CITY FILE NUMBER	CHANGES TO PLANS	APPROVAL DATE
CPC DP 02-0253	Beth-El Mennonite Church Development Plan	(2002)
AR NV 09-00036	nonuse variance for additional wall signage	(2009)
PDZ-25-0020	minor modification to add preschool use	(Summer 2025)

UPDATED 5-9-25

BETH-EL MENNONITE CHURCH

PDZD-25-0020

LS1

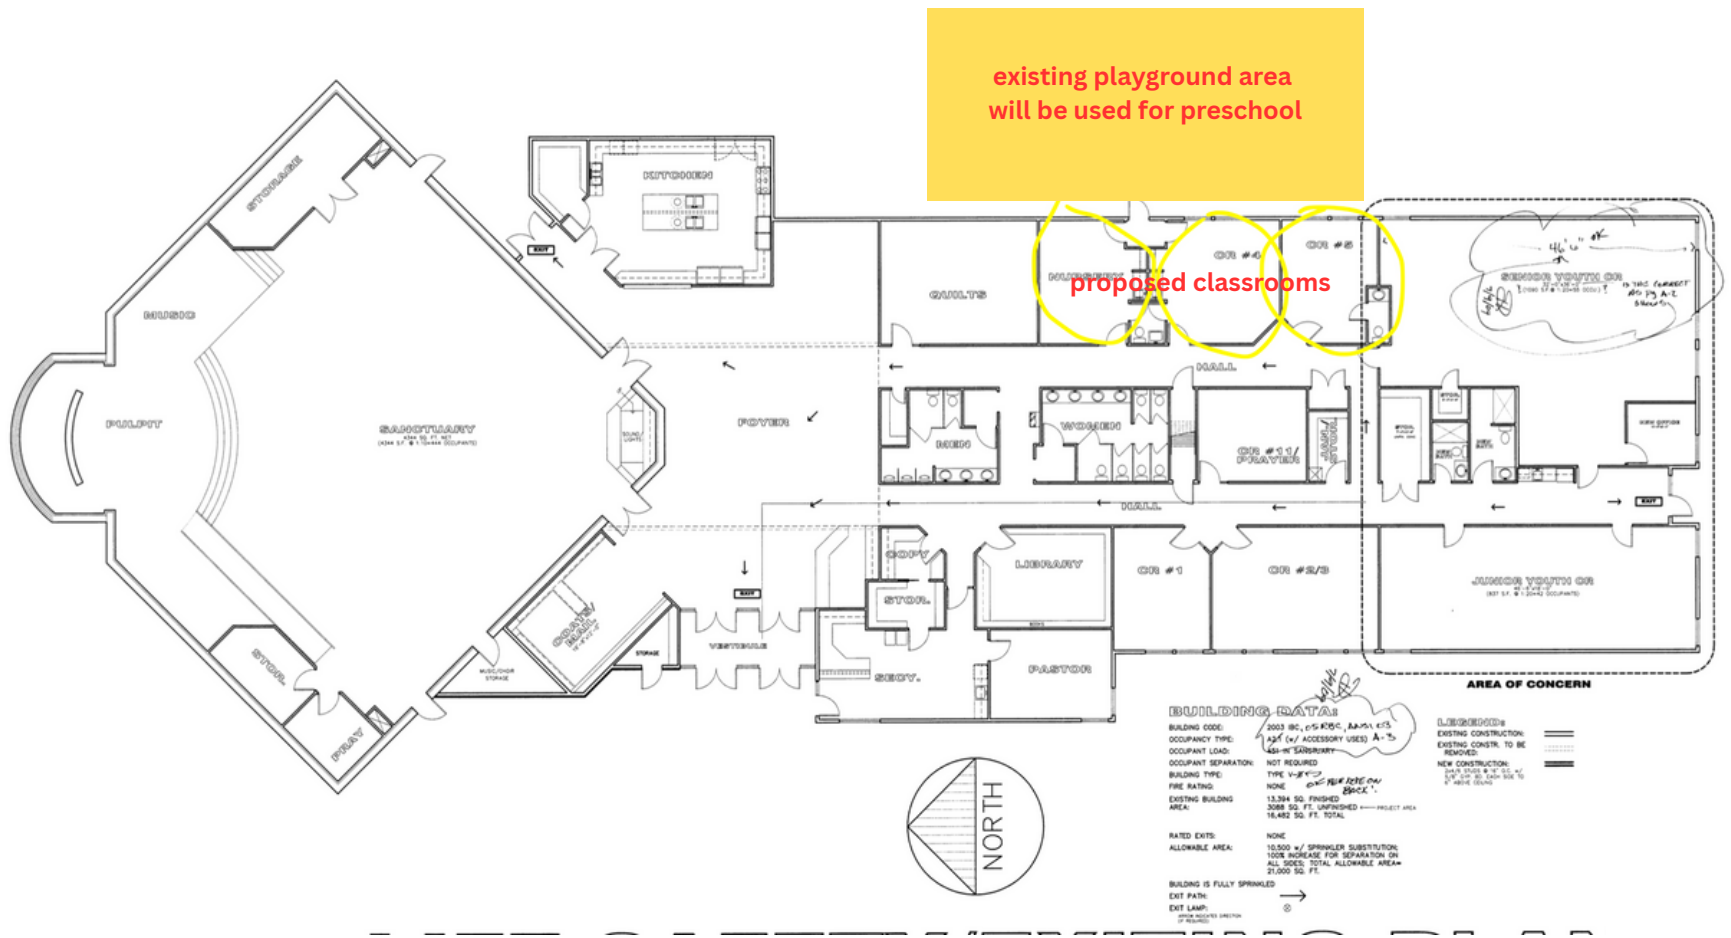
existing playground area
will be used for preschool

proposed classrooms
